March 3, 2021
10258372

City of Hudson Planning Board
520 Warren Street
Hudson, NY 12534

Re: Verizon Wireless Proposed Rooftop Installation
119 Columbia Street, Hudson, New York 12534
Technical Memorandum

Figure 6 – Proposed Coverage (2100Mhz)

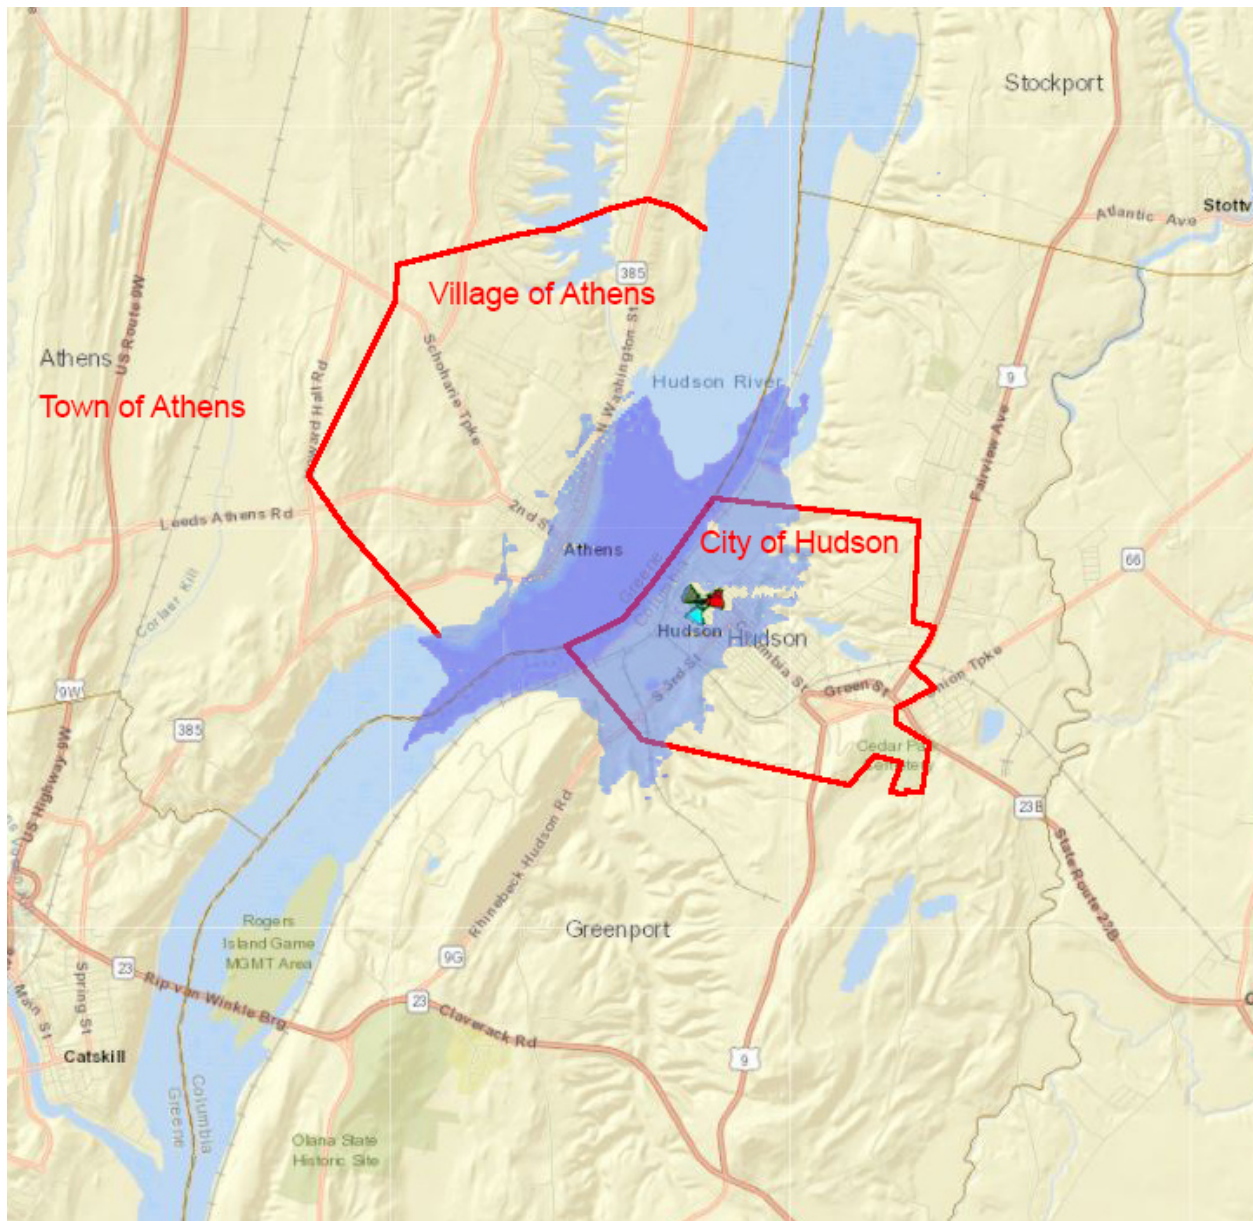
As can be seen in the image below, much of the downtown commercial, residential, and waterfront areas in the City of Hudson would receive 2100Mhz coverage with the proposed site, while none of the Village of Athens would receive high band coverage.

It must be noted that Figures 5 and 6 are simple geographic analyses of coverage maps (low band and high band frequencies) overlaid on municipal boundaries. They do not necessarily depict the known capacity issues. As Verizon is licensed by the FCC to operate at both low and high band frequencies, the coverage and capacity data submitted for the 119 Columbia Street application appears to support the statement that service from the site – if approved and constructed – will predominately service the City of Hudson.
